Note verbale 027 and Fire Protection for the Ventilation Duct Penetrations

Amended Rules and Guidance

Rules for the Survey and Construction of Steel Ships Part R

Outline of Amendment

Fig. 2.2.3-2 A Duct Penetration with a Free Cross-sectional Area of over 0.075 m^2
(Damper Provided on One Side of the Division.)

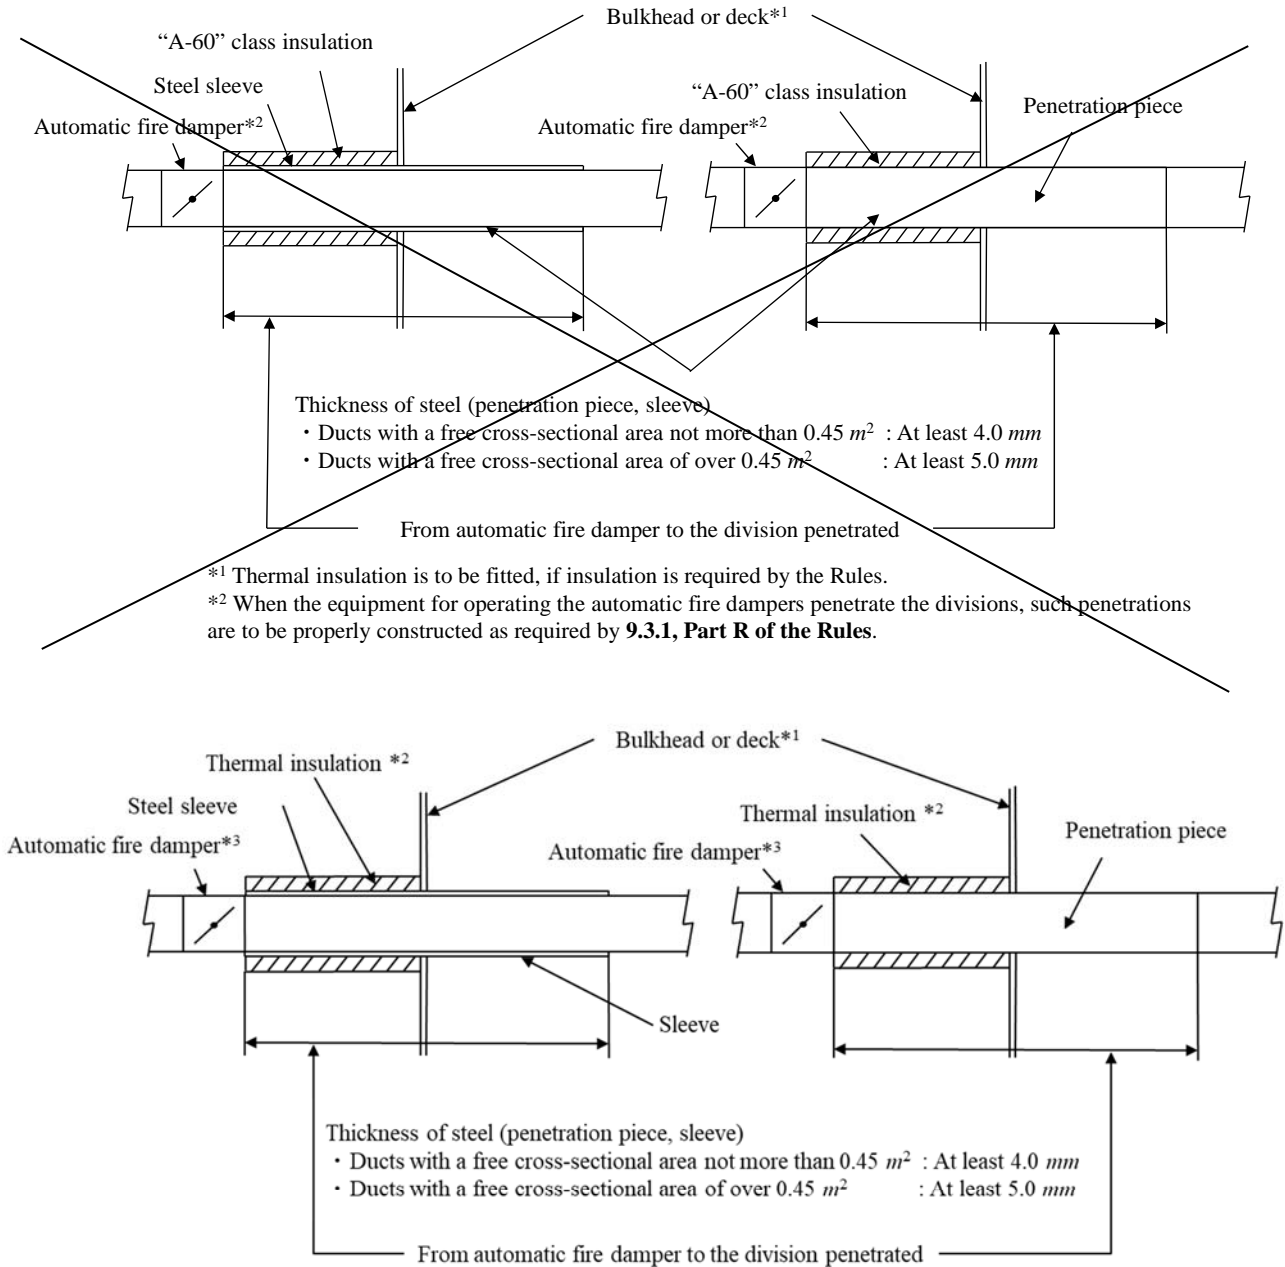
Fig.2.2.3-2 and Fig.2.2.3-3 have been amended as follows.

^{*2} Thermal insulation same level of fire integrity of the penetrated bulkhead or deck to be fitted.

^{*3} When the equipment for operating the automatic fire dampers penetrate the divisions, such penetrations are to be properly constructed as required by 9.3.1, Part R of the Rules.

2 The details of prevention of heat transmission between automatic fire dampers and the divisions penetrated specified in **9.7.3-1(3), Part R of the Rules** are to be as shown in **Fig. 2.2.3-2** and **Fig. 2.2.3-3** as a standard.

Fig. 2.2.3-3 A Duct Penetration with a Free Cross-sectional Area of over 0.075 m^2
(Dampers Provided on Both Sides of the Division.)

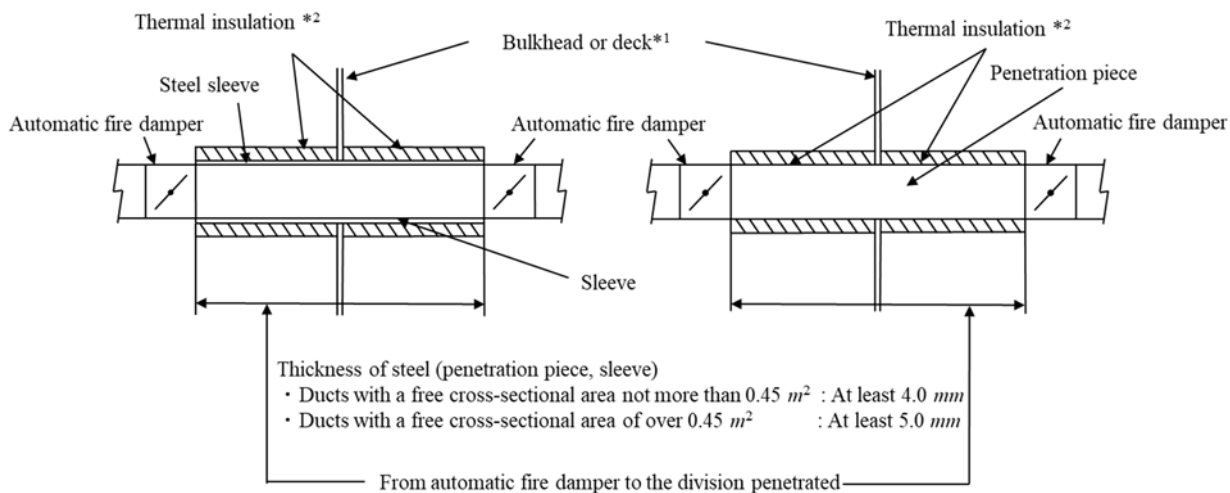
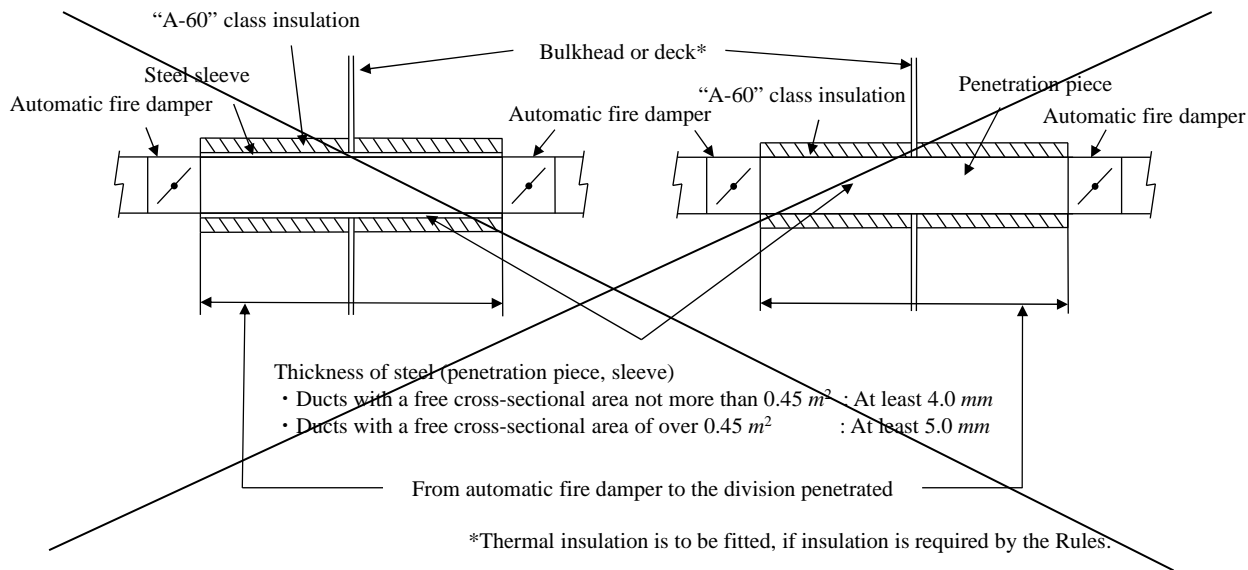
*2 Thermal insulation same level of fire integrity of the penetrated bulkhead or deck is to be fitted.

Fig. 2.2.3-1 A duct penetration with a free cross-sectional area equal to, or less than, $0.075 m^2$

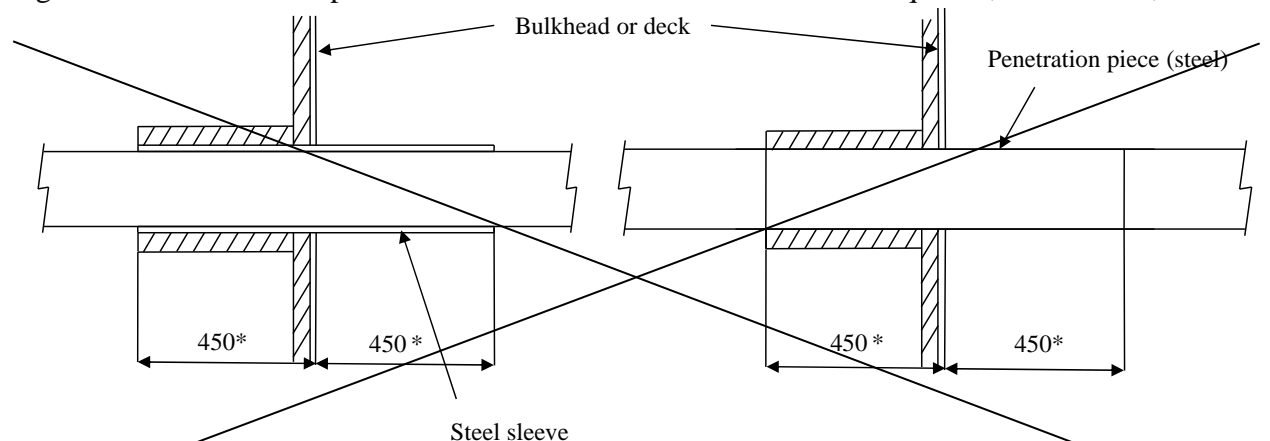
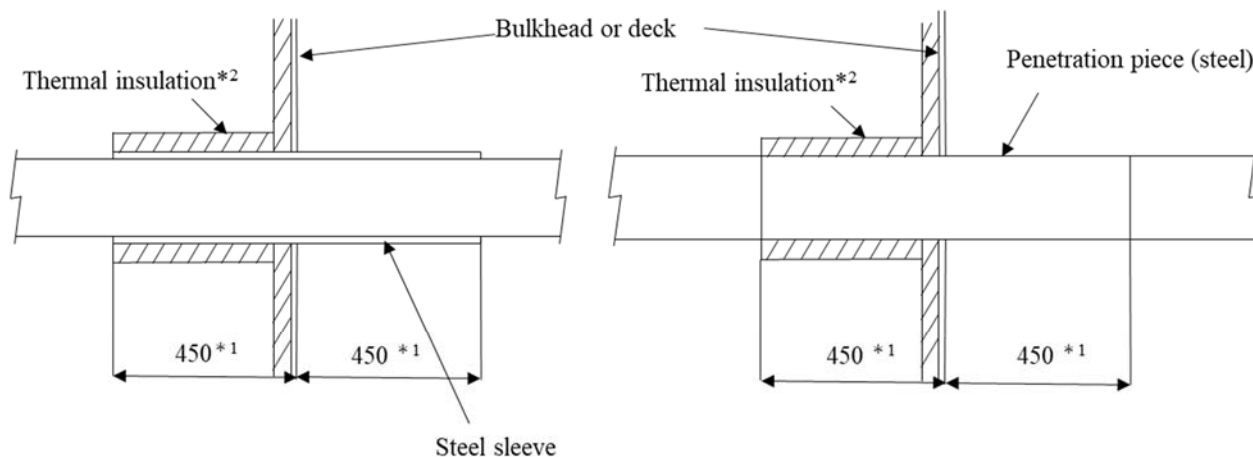
Fig.2.2.3-1 has been amended as follows.

* A penetration of a duct made of material having low-heat conductivity character and with a free cross-sectional area not greater than $0.02 m^2$, the insulation may be terminated at the end of penetration piece or sleeve specified in 2.2.1.

*1 A penetration of a duct made of material having low-heat conductivity character and with a free cross-sectional area not greater than $0.02 m^2$, the insulation may be terminated at the end of penetration piece or sleeve specified in 2.2.1.

*2 Thermal insulation is to be provided only to the part of the duct and/or sleeve that is on the same side of the division being fire insulated, and be extended for a minimum of 450mm along the duct and/or sleeve.

1 The details of prevention of heat transmission at penetrations specified in (1) and (2) of 9.7.3-1, Part R of the Rules are to be as shown in Fig. 2.2.3-1 as a standard.
